# Access Compliance Report

### (Curb Ramps)

Intersection ID: 25370	Main Street: PEVERELL_LN	Cross Street: PROVIDENCE_PLANTATION_LN	Location: S
ADA ID: FCDB8C759984	Ramp Type: Perp	Initial Pass/Fail: Fail	Overall Compliance: No
Severity Score: 36.25			
Codes/Mitigation Info/Possible Solution		Field Measurements/Component Compliance

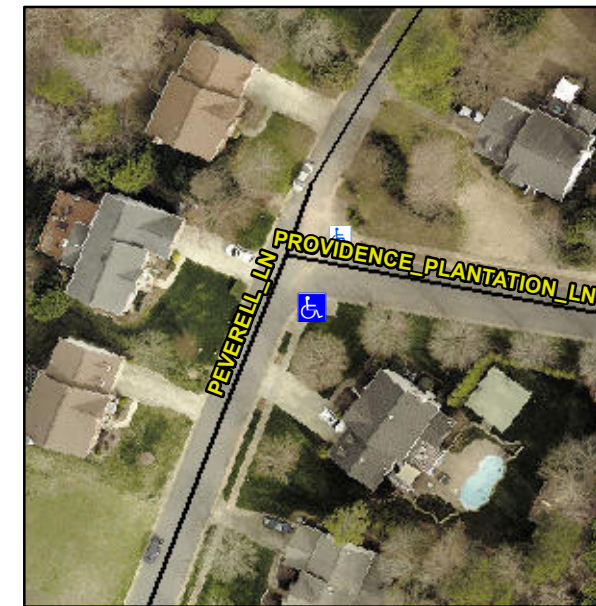
**Not Found, R304.5.1, R304.5.3**

Compliance	Description	Data	Compliance	Description	Data
N/A	Ramp Length (in)	96.0	Yes	Ramp Slope (%)	5.5
No	Ramp Width (in)	25.0	No	Ramp XSlope (%)	4.1
N/A	Flare Type LT	N/A	N/A	Flare Type RT	N/A
N/A	Flare Slope LT (%)	N/A	N/A	Flare Slope RT (%)	N/A
N/A	Flare Traversable LT?	N/A	N/A	Flare Traversable RT?	N/A
N/A	Landing Length (in)	N/A	N/A	DWS Provided?	N/A
N/A	Landing Width (in)	N/A	N/A	DWS Contrast?	N/A
N/A	Landing Slope (%)	N/A	N/A	DWS Length (in)	N/A
N/A	Landing X Slope (%)	N/A	N/A	DWS Full Width?	N/A
N/A	Landing Curb? (Y/N)	N/A	N/A	DWS Offset (in)	N/A
N/A	Shared Landing?	N/A			
N/A	Gutter Ponding?	N/A	N/A	Gutter Slope (%)	N/A
N/A	Gutter Lip Ht (in)	N/A	N/A	Gutter X Slope (%)	N/A
N/A	Painted X Walk1?	No	N/A	Painted X Walk2?	N/A
	X Walk 1 Direction	To NE		X Walk 2 Direction	N/A
N/A	X Walk 1 Width (in)	N/A	N/A	X Walk 2 Width (in)	N/A
	X Walk 1 Slope (%)	3.3		X Walk 2 Slope (%)	N/A
	X Walk 1 X Slope (%)	1.1		X Walk 2 X Slope (%)	N/A

**Remove & Replace Entire Ramp.**
